ARCHITECTURAL REVIEW BOARD MEETING
CITY HALL, 385 SOUTH GOLIAD, ROCKWALL, TEXAS
OCTOBER 11, 2022 IN THE CITY COUNCIL CONFERENCE ROOM AT 5:00 PM

(1) **SP2022-050 (HENRY LEE)**

TO: Planning and Zoning Commission
DATE: October 11, 2022
APPLICANT: Jeff Carroll; *Jeff Carroll Architects*
CASE NUMBER: SP2022-050; *Amended Site Plan for Bacon Plumbing*

Re: SP2022-050 Variance Requested
Bacon Properties Development Phase 2
Rockwall, TX.

EXTERIOR ELEVATIONS

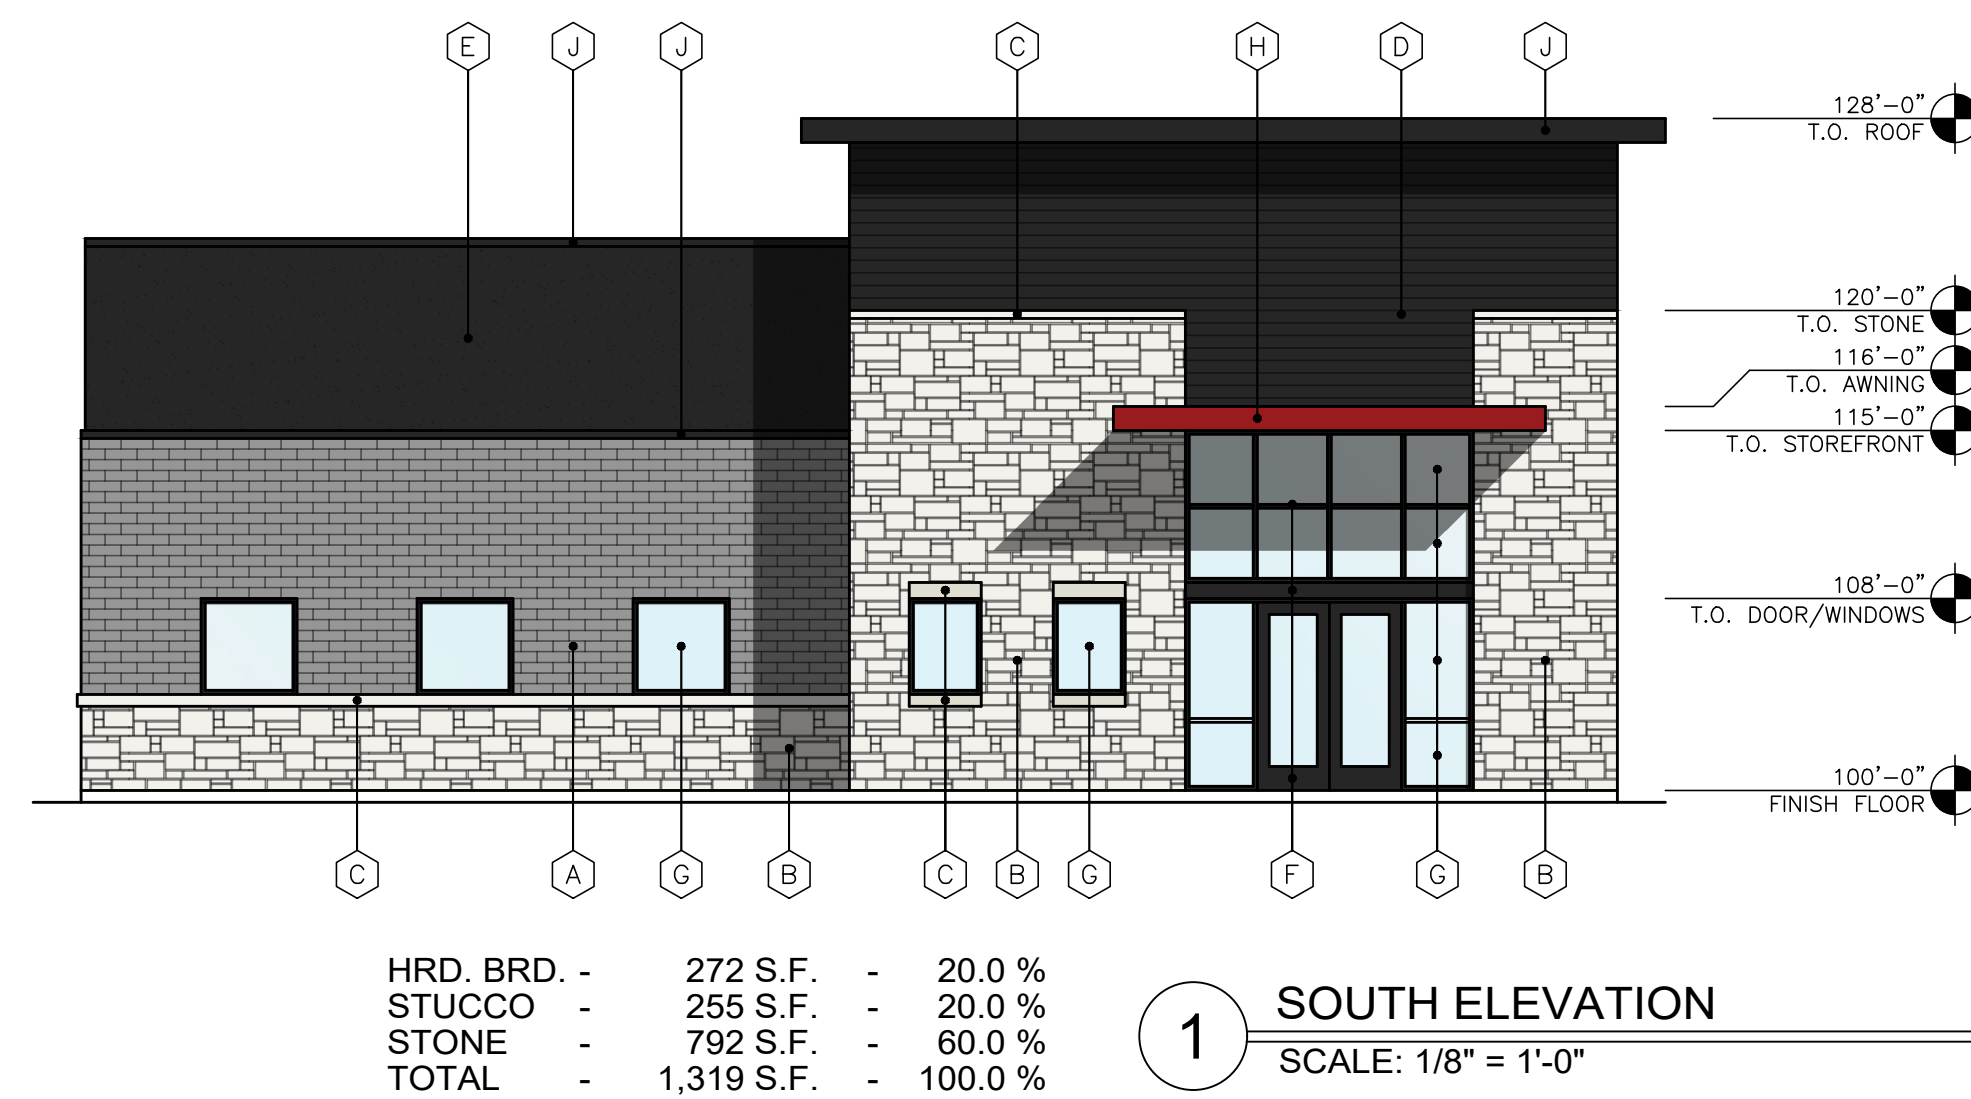
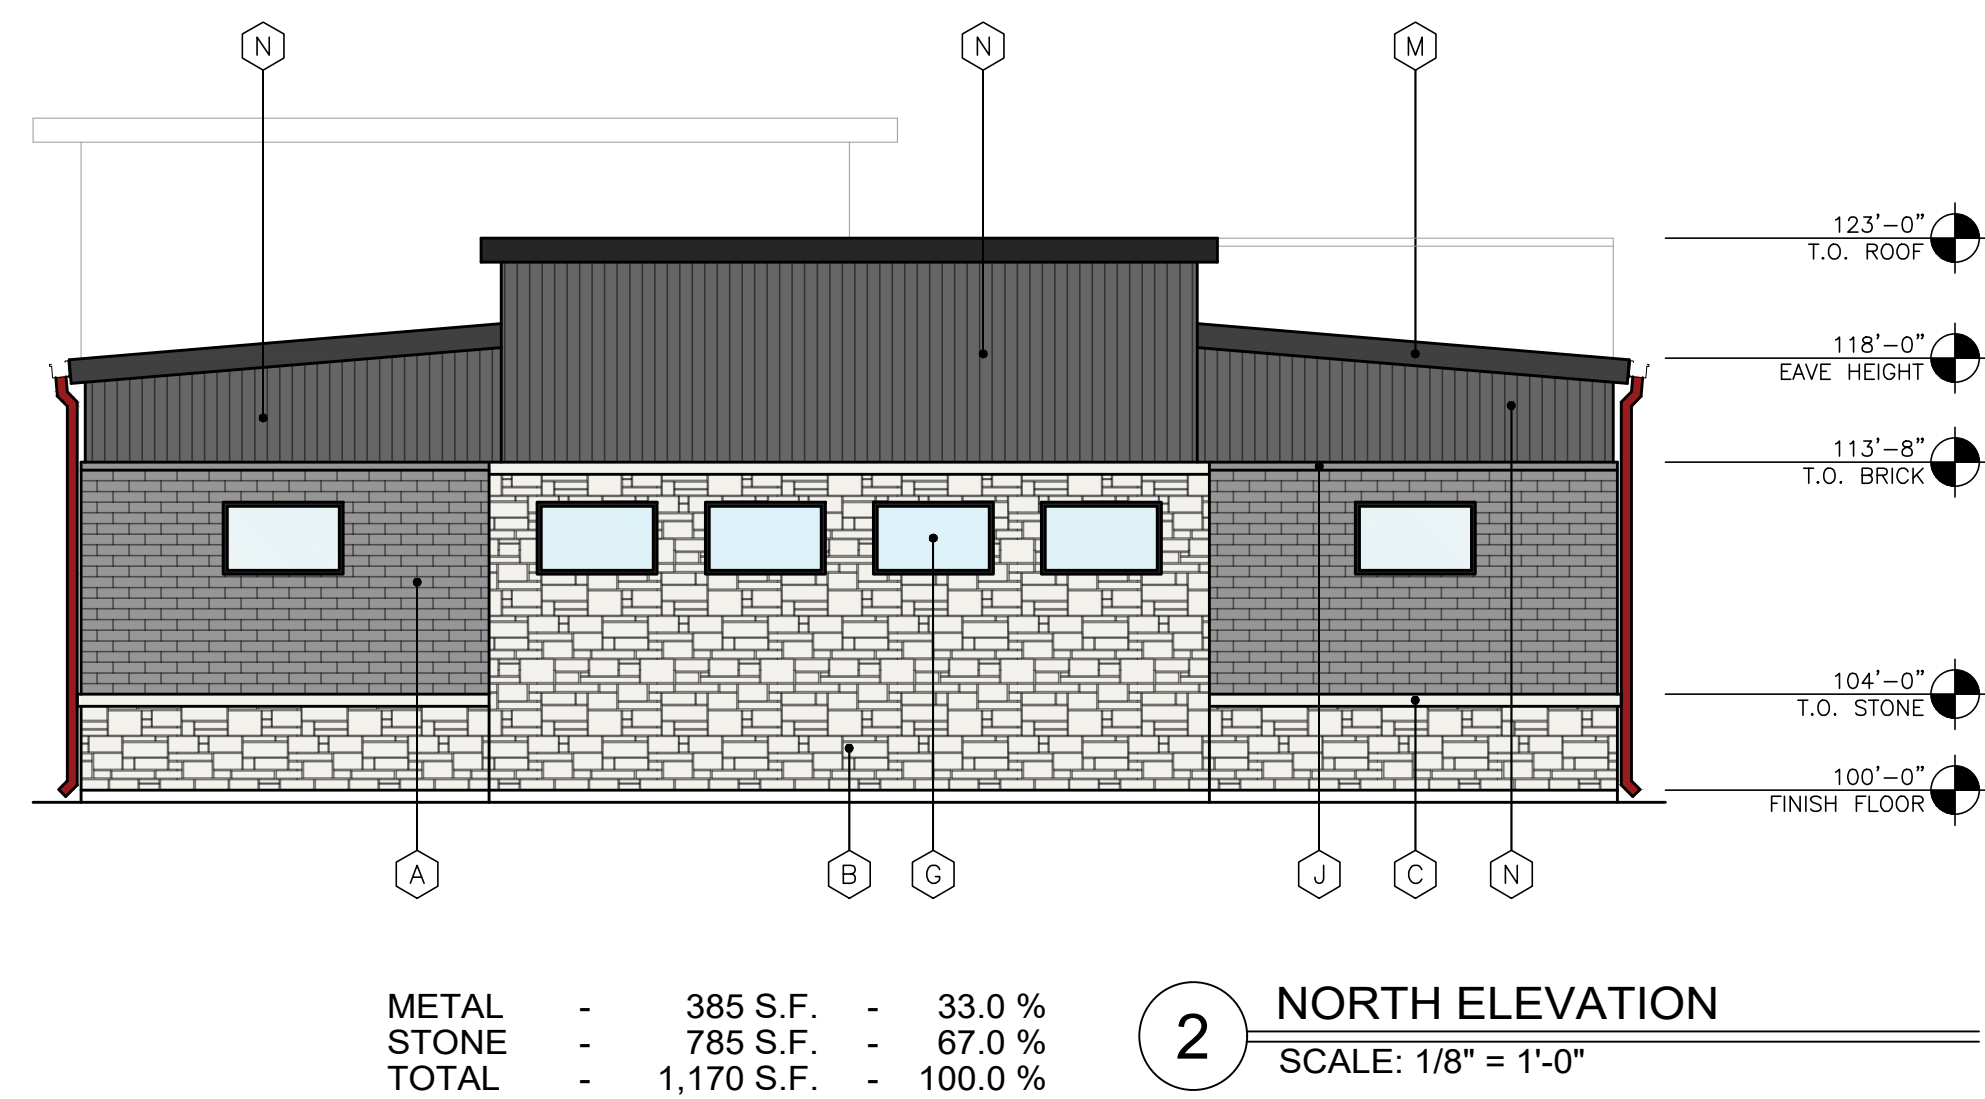
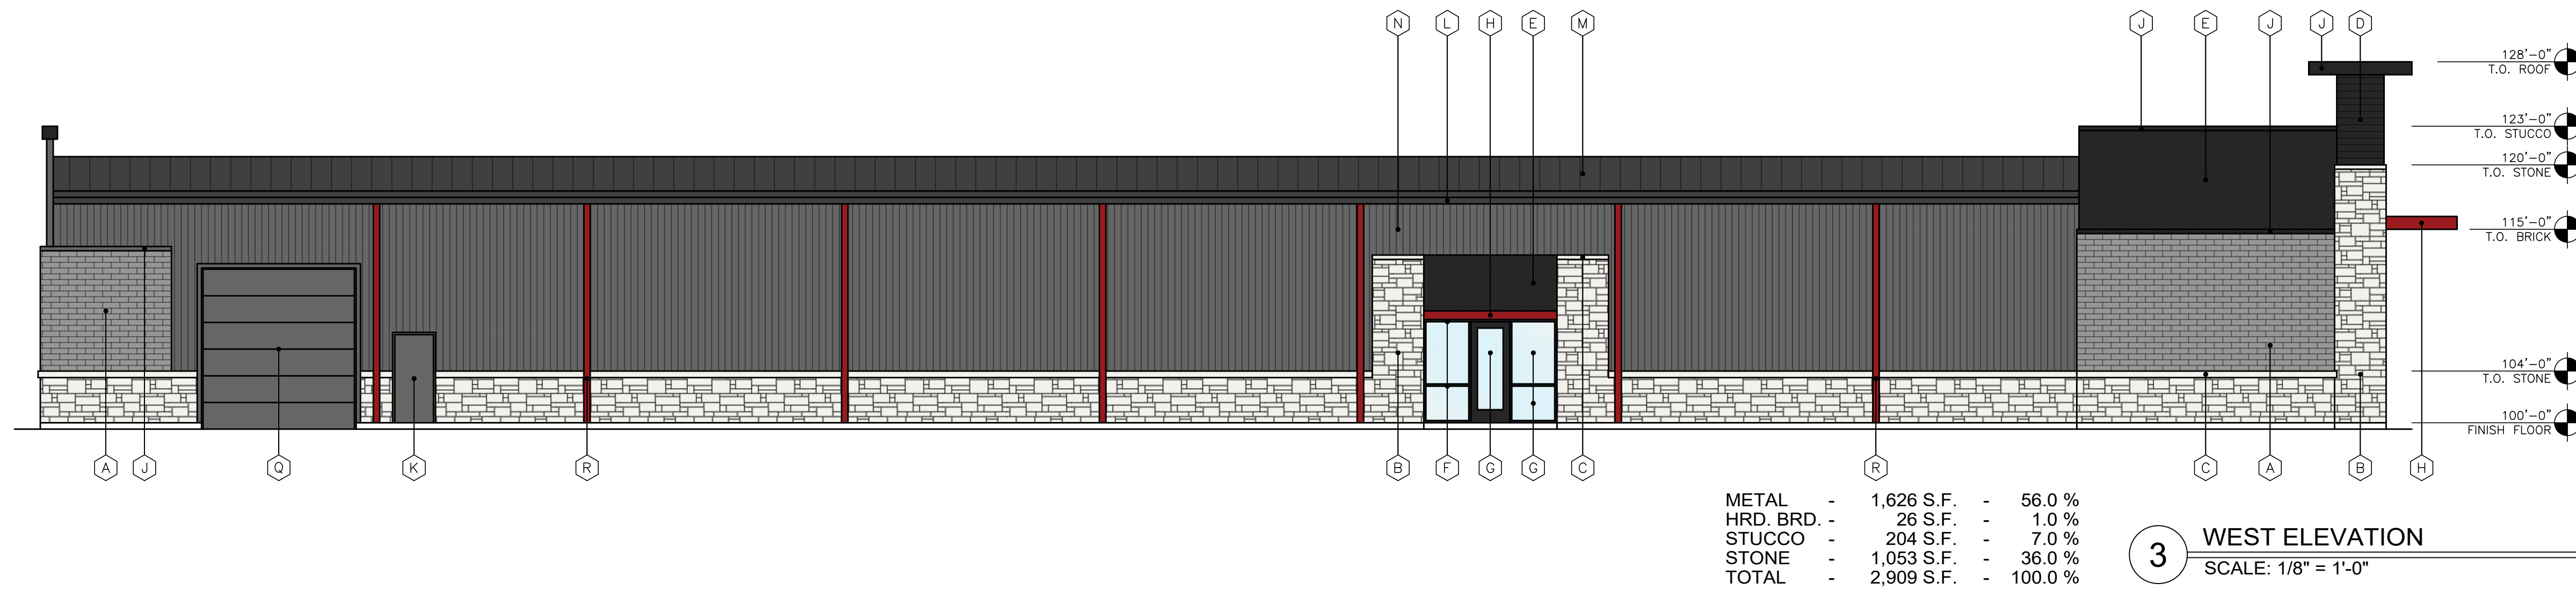
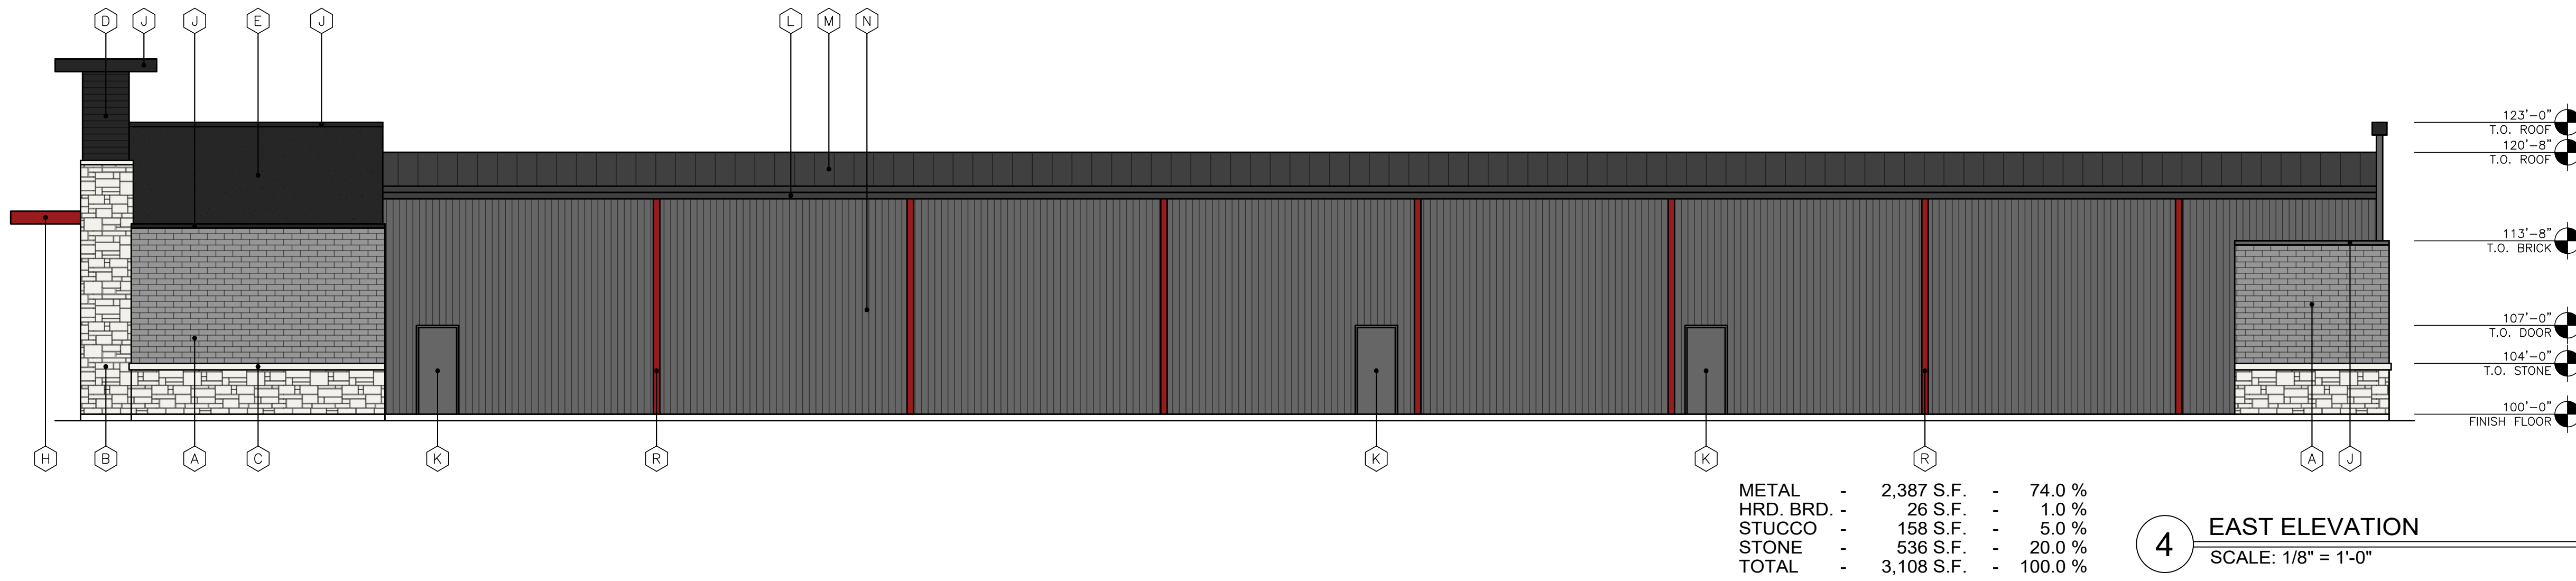
On September 27, 2022 the Architecture Review Board (ARB) reviewed the proposed building elevations and recommended that the applicant [1] add depth to the projecting element on the south elevation and [2] dress up the rear elevation to better match the front elevation. The applicant has provided updated elevations that will be reviewed by the Architectural Review Board (ARB) prior to the October 11, 2022 Planning and Zoning Commission meeting.

This letter serves as a summary of the Request for Variances to the UDC within the I-30 overlay district. The Variances include (1) **Secondary Material greater than 10% material**, (2) **Four-sided Architecture**.

We are requesting a variance to increase the Building Secondary Material. We are providing metal siding wall panels exceeding 50% at the east and west side elevations of our new proposed building. The stone material provided for these sides are 20% or more.

We are requesting a variance for reducing required materials on the east side of the new building. We are showing the new building expansion and the existing building on the site plan where no one will see between the two buildings. We are also bringing the building materials from the front onto the sides 20'.

- A) We have added tower elements for horizontal articulation on the front and rear elevations for street views. We are providing a flat awning at the entry tower to help the articulation.

- B) City Ordinance requires 15% landscaping area. We are proposing 50% which is 3x more than required by zoning code.
- C) We have provided more stone than required. The North elevation = 67%, South elevation = 60%, West elevation = 36%.
